2301 7th Avenue  
DRB Response - REC Meeting #2  
Date: February 11, 2020  
SDCI Project Number: 3034280-LU

This package is in response to DRB comments from the September 24th, 2019 REC meeting with the goal of addressing all the comments and concerns from that meeting. The specific DRB comments and applicant responses are summarized on pages 4 and 5. Subsequently, each specific DRB comment has a response through graphics and text.

## DRB Guidance - SDCI notes of 09/24/2019 Rec. Meeting

## Summary of Applicant Response to DRB Guidelines

DRB Guidance - 5. Context  
Alley Side Podium Comparison (Materials)

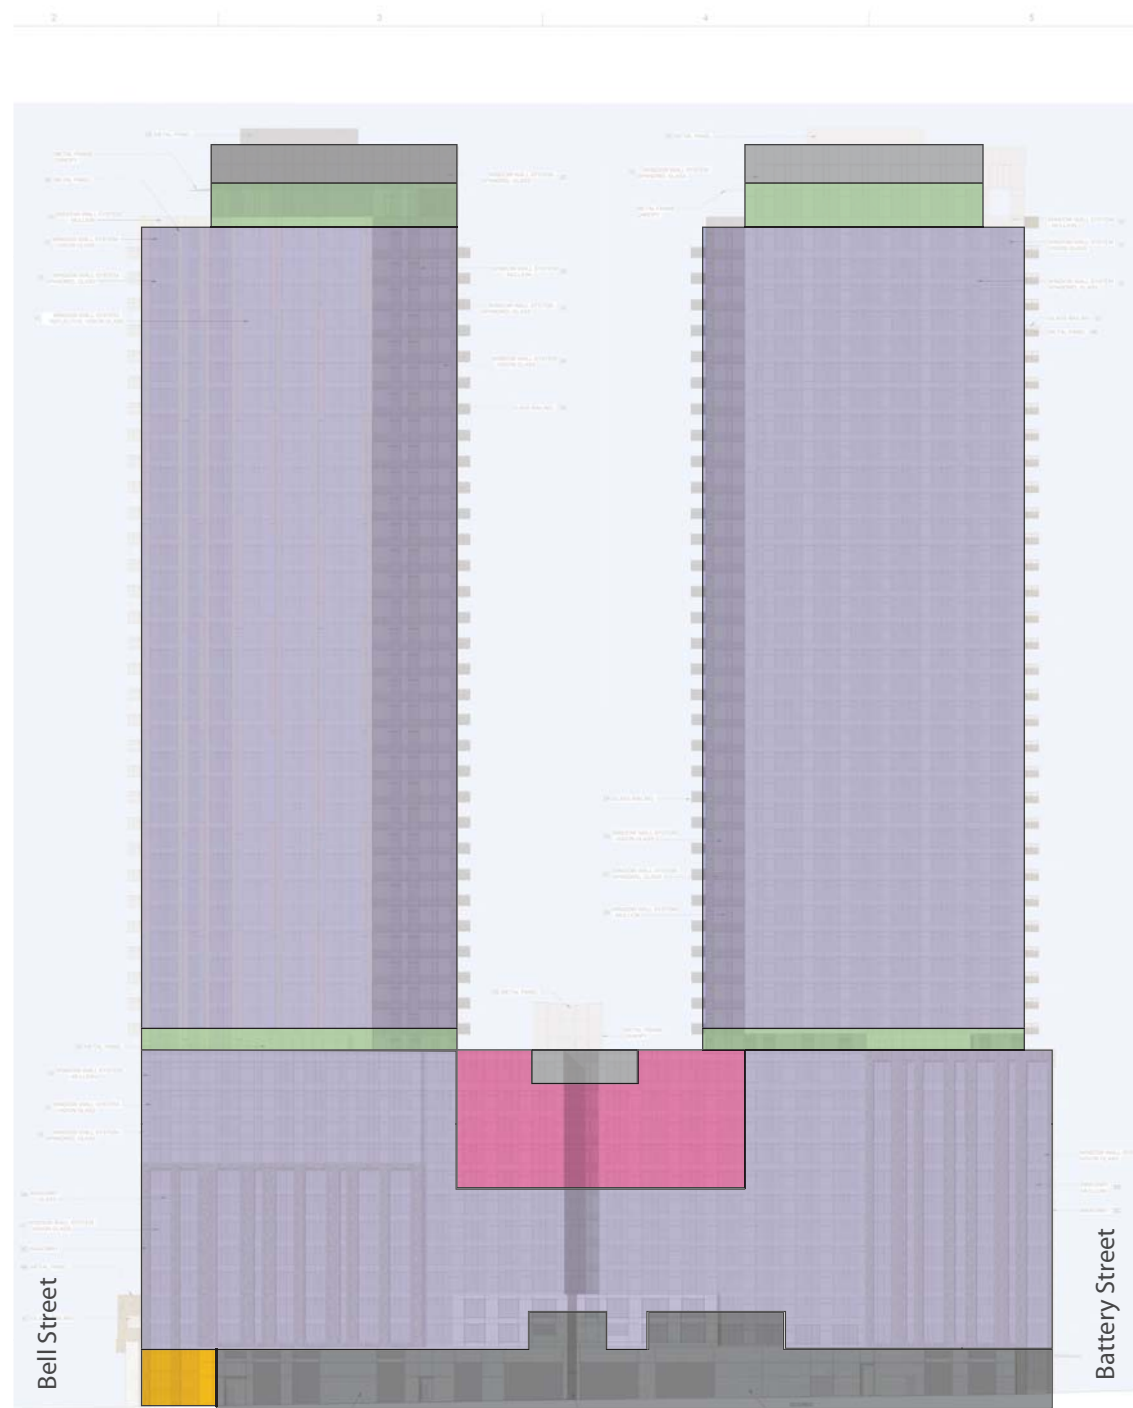
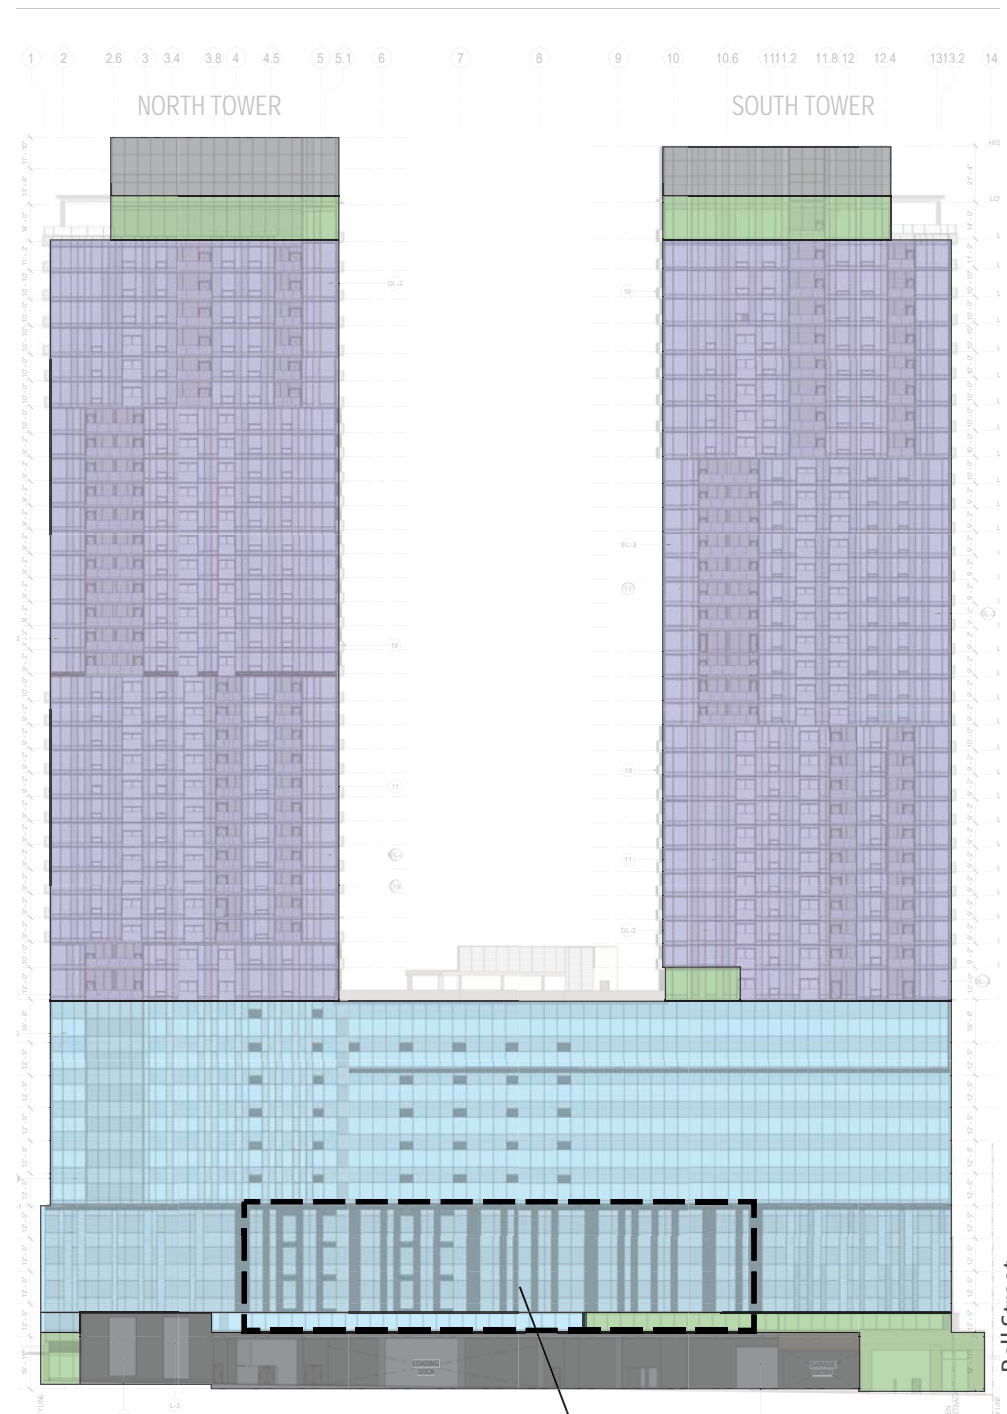
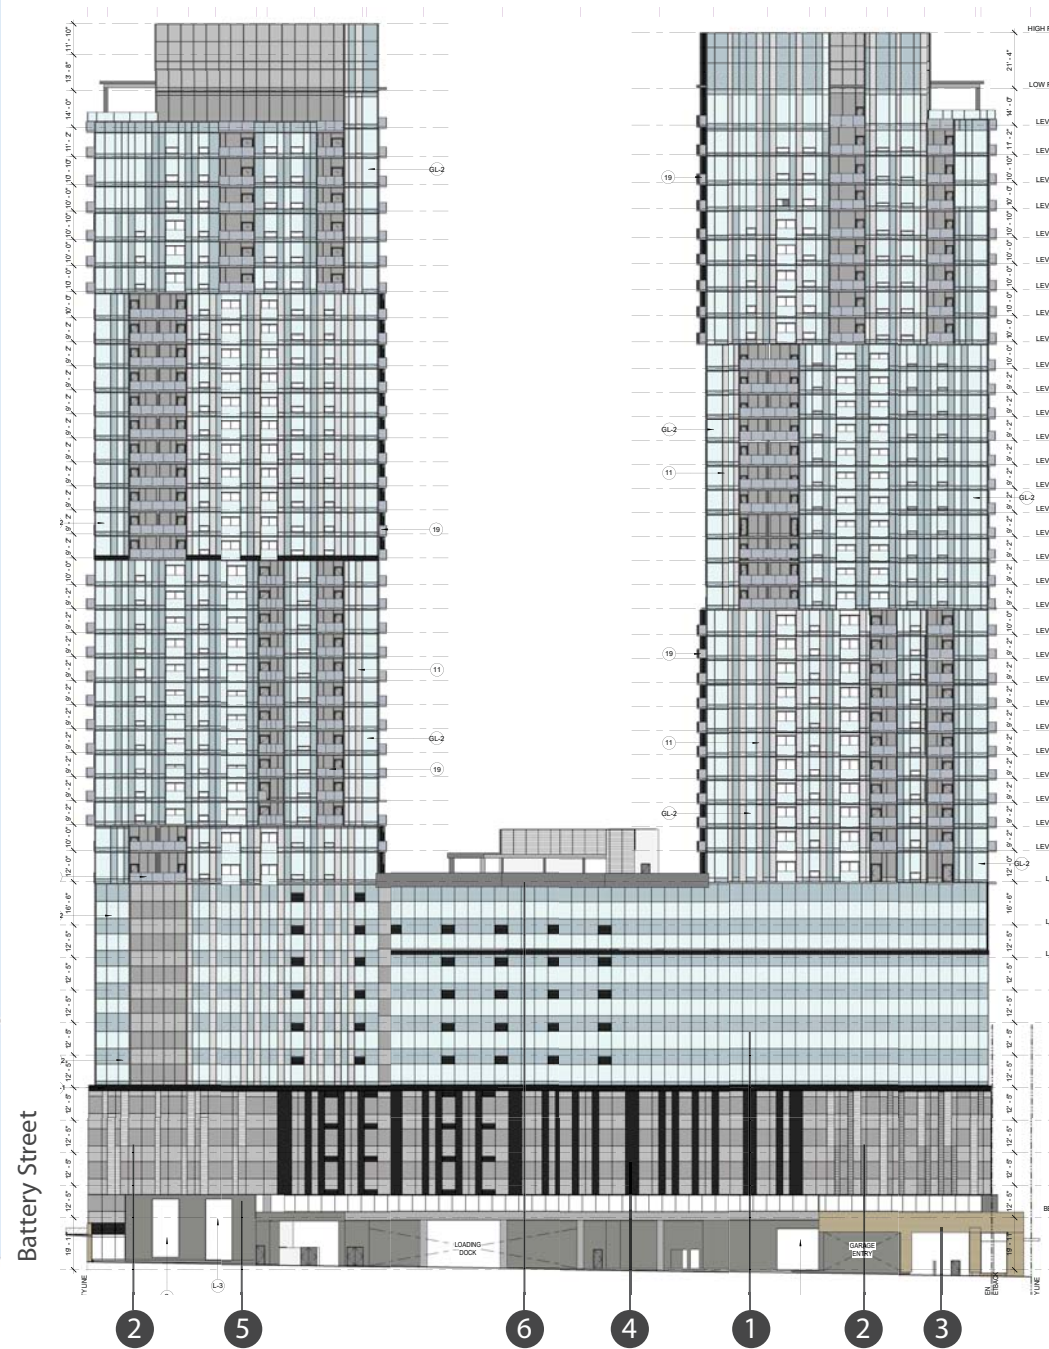
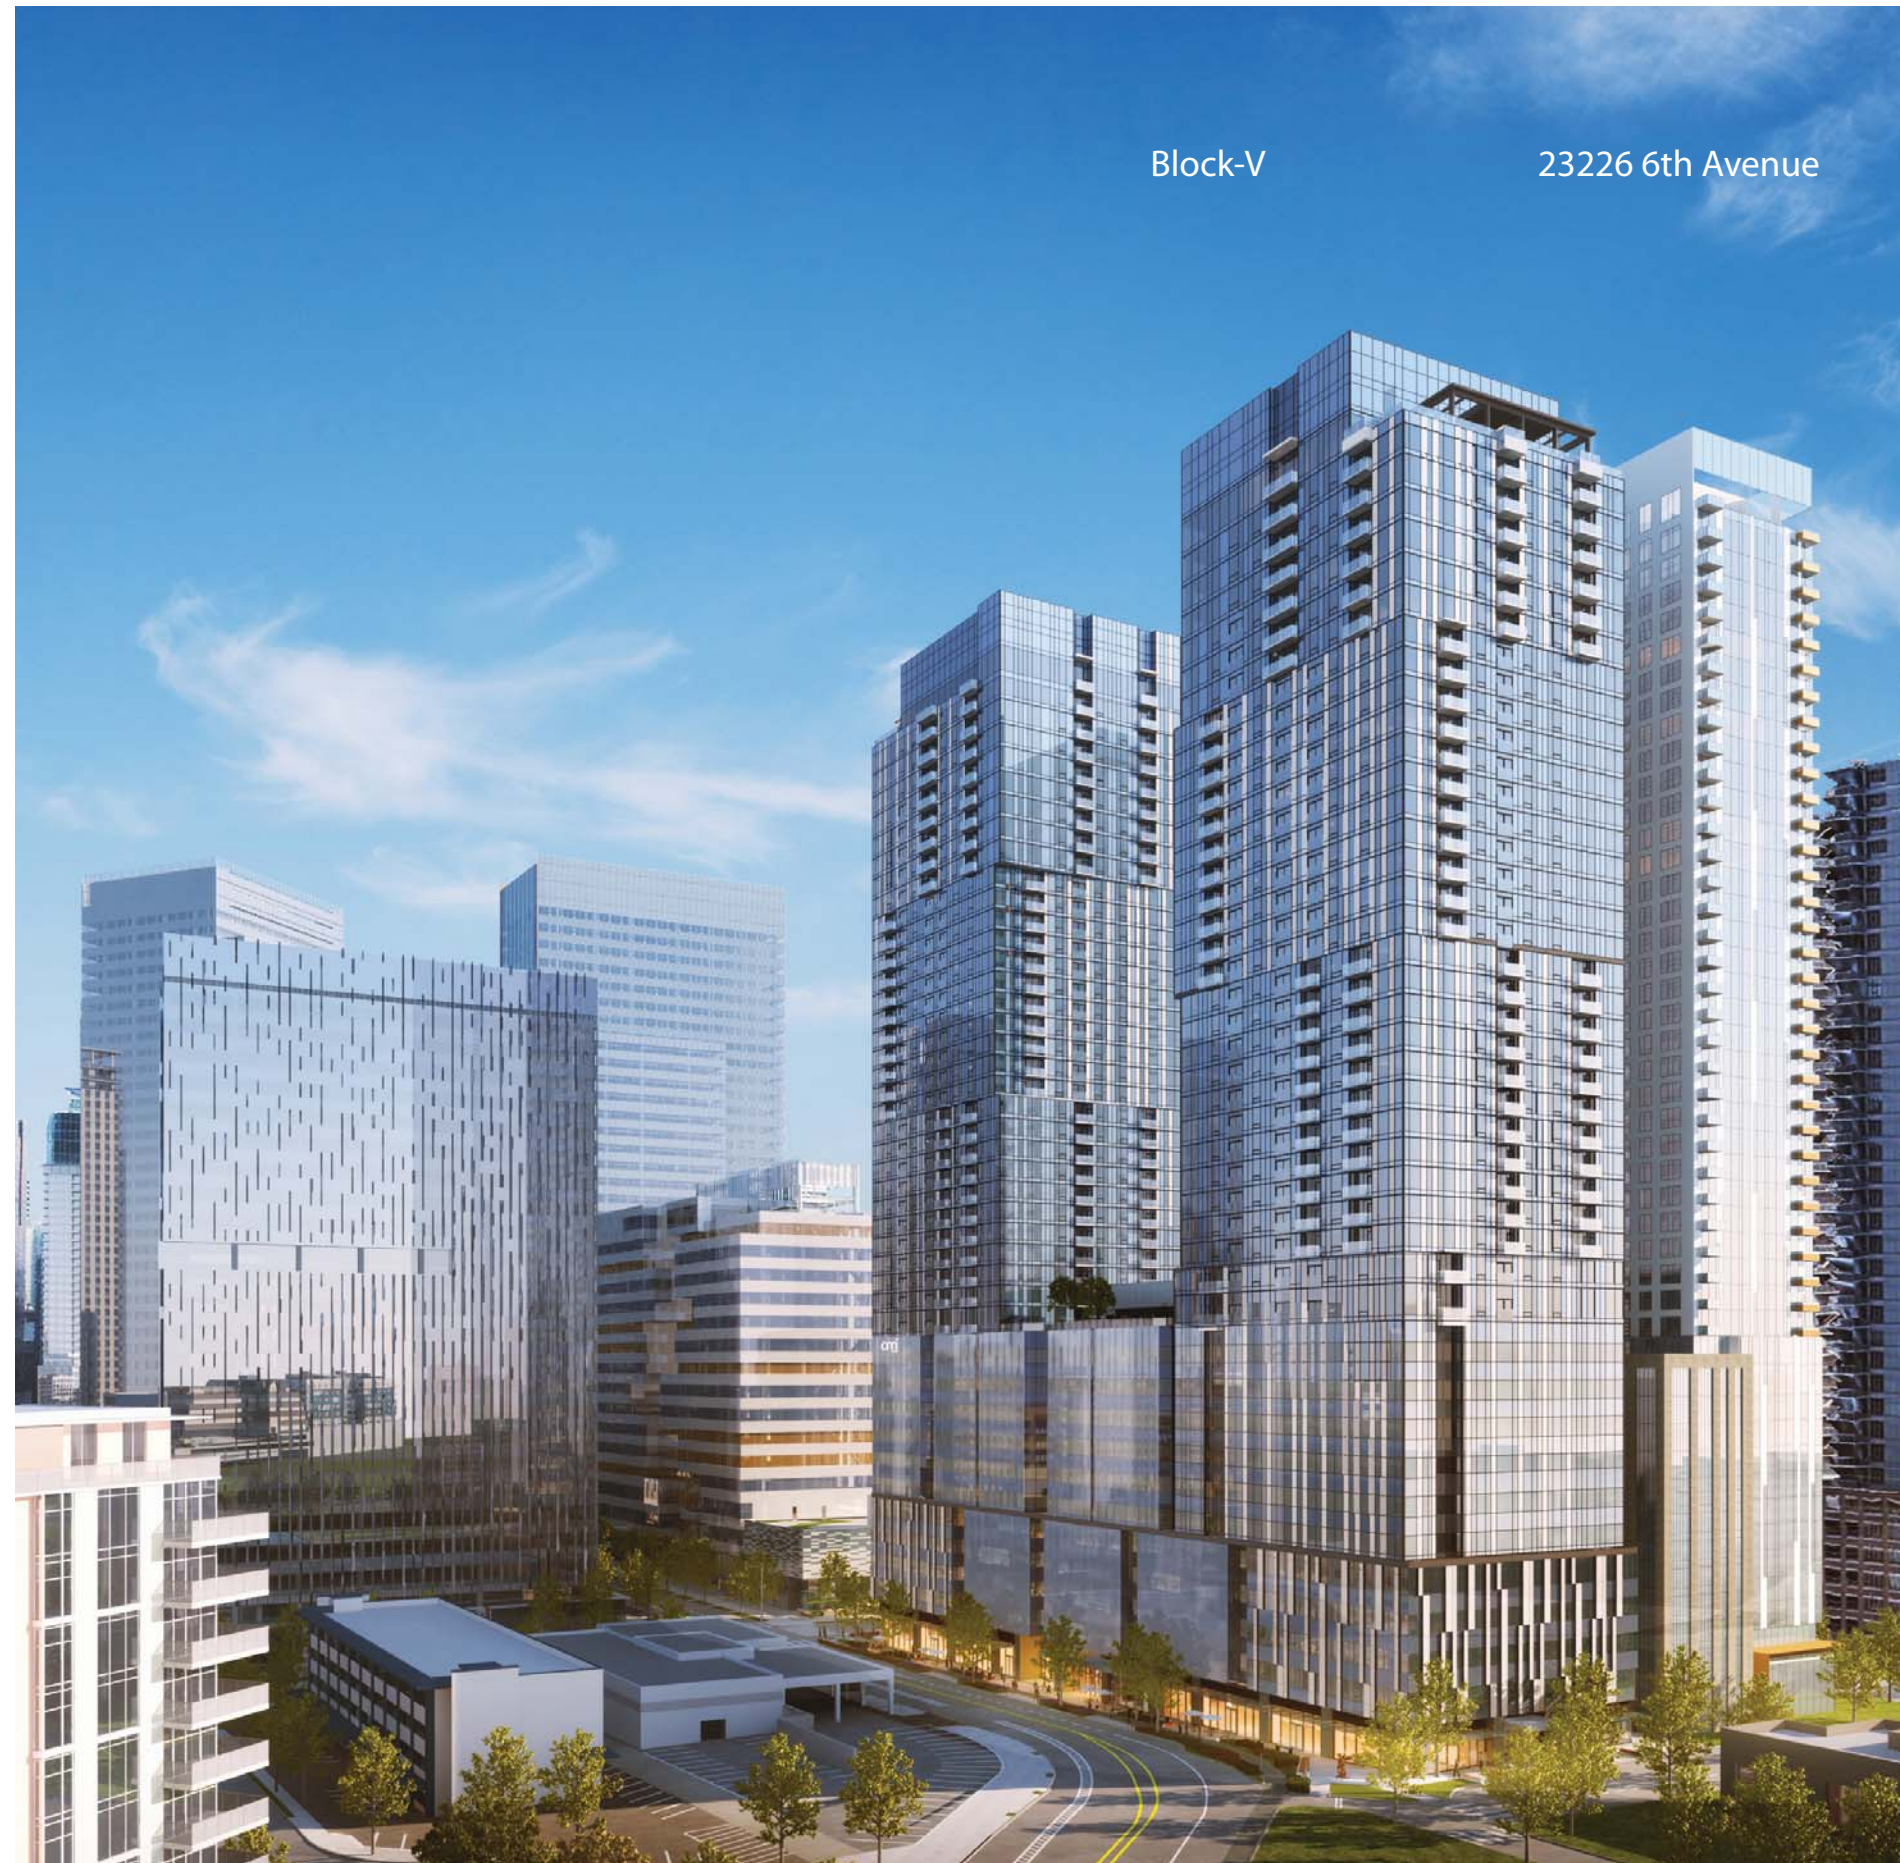
a. The Board agreed that they required design related information about the neighboring project in order to fully evaluate the revised design. The Board directed the applicant to include that information for the next meeting. (A-1, B-2, B-3, C-6)

Material and program comparisons are shown here and on the previous page. Block-V's materials are comparable in quality to the adjacent property, are continued around from 7th avenue and fully support the overall design concept and composition of the project.

**Departure Request 1**

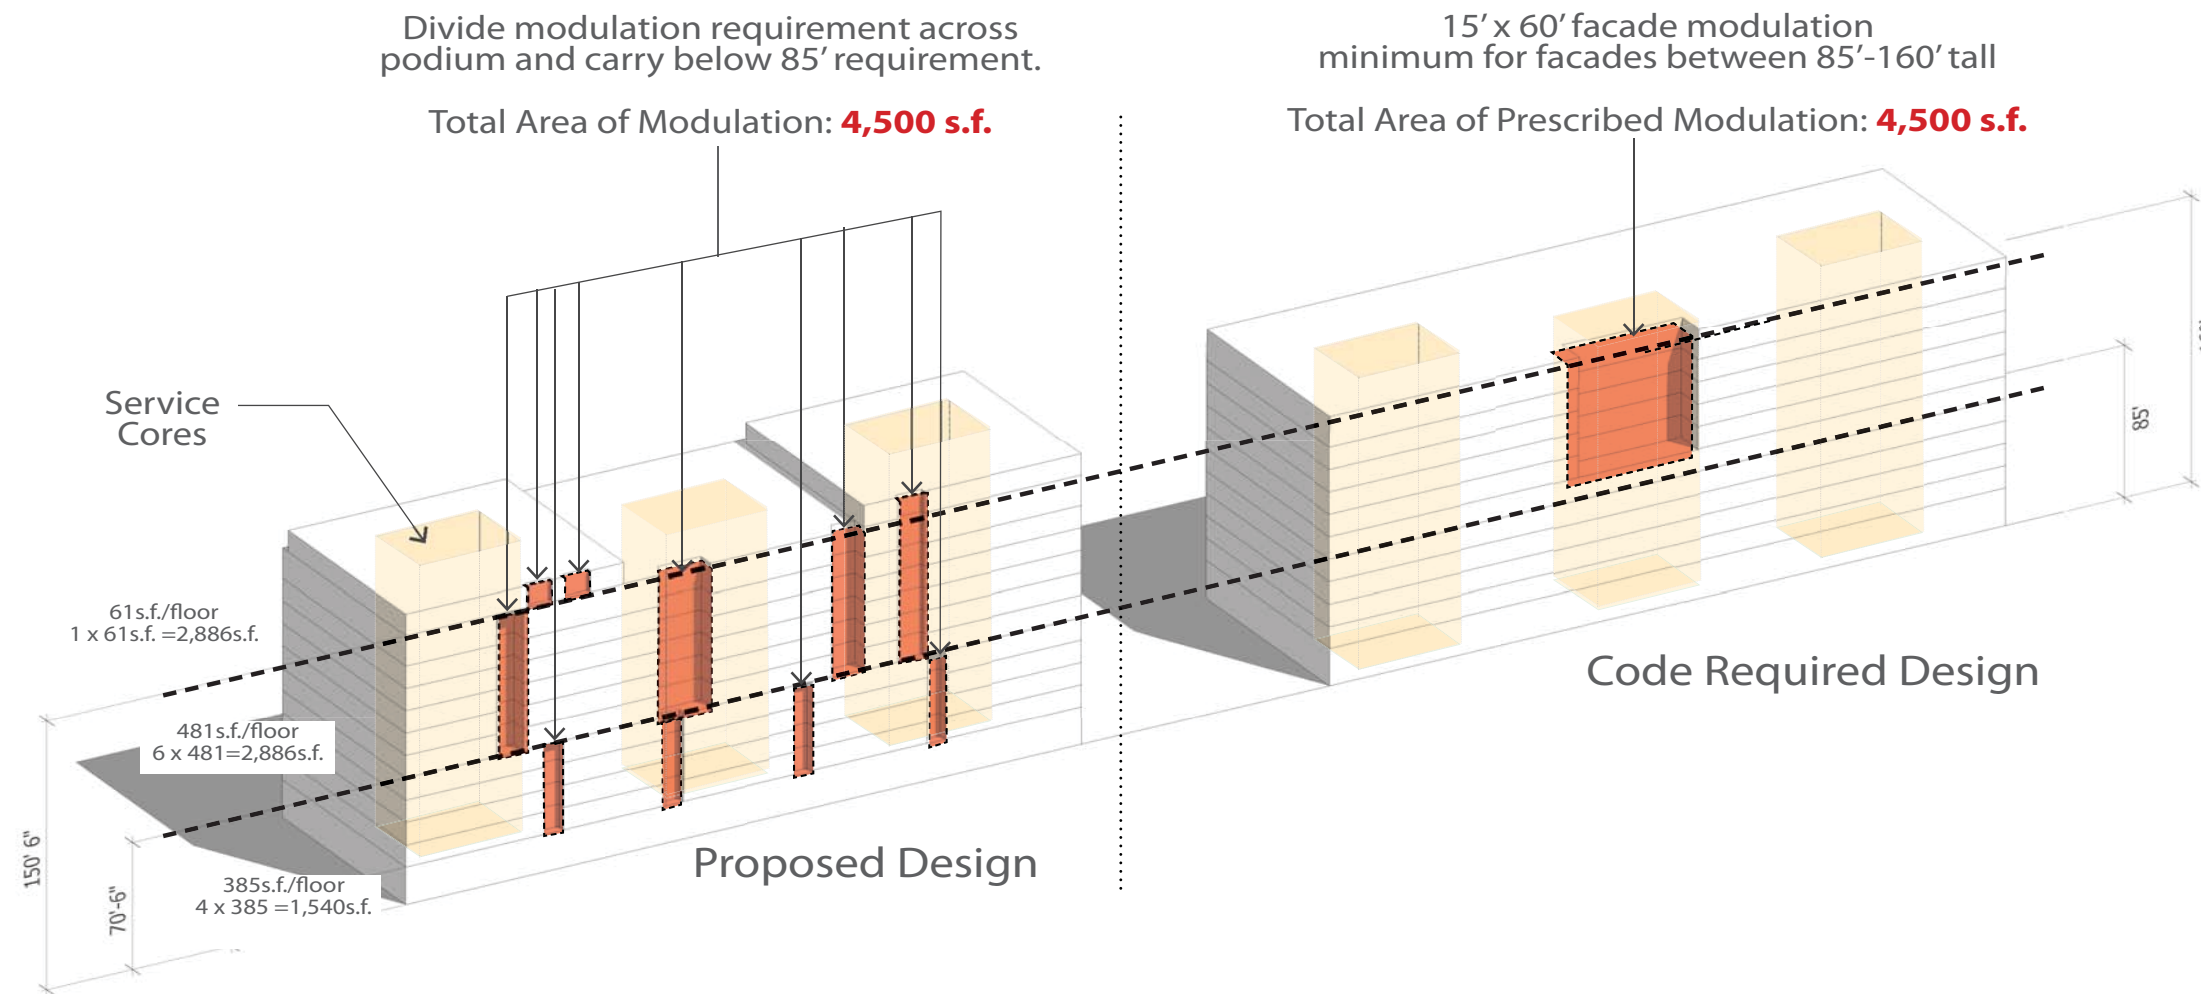
d. The Board stated that support for the departure request on modulation would be contingent on the successful resolution of the issues identified above, noting that the number, scale and composition of notches should be carefully considered. (B-1, B-2)

We request a design departure for the prescribed podium level modulation. The mixed-use program of Block V requires 3 large support cores. Given the reduced depth of the half block site, the prescribed modulation depth of 15' for 60' in length will result in compromised leasing depths along the main facade (7th Avenue). We propose splitting this modulation throughout the 7th Avenue facade reducing the overall mass in multiple locations, bringing it closer to the pedestrian level. The overall composition of the project is based on this modulation departure, has been present from Early Design Guidance and had been previously approved and documented in the Approved MUP design of April 11, 2017.
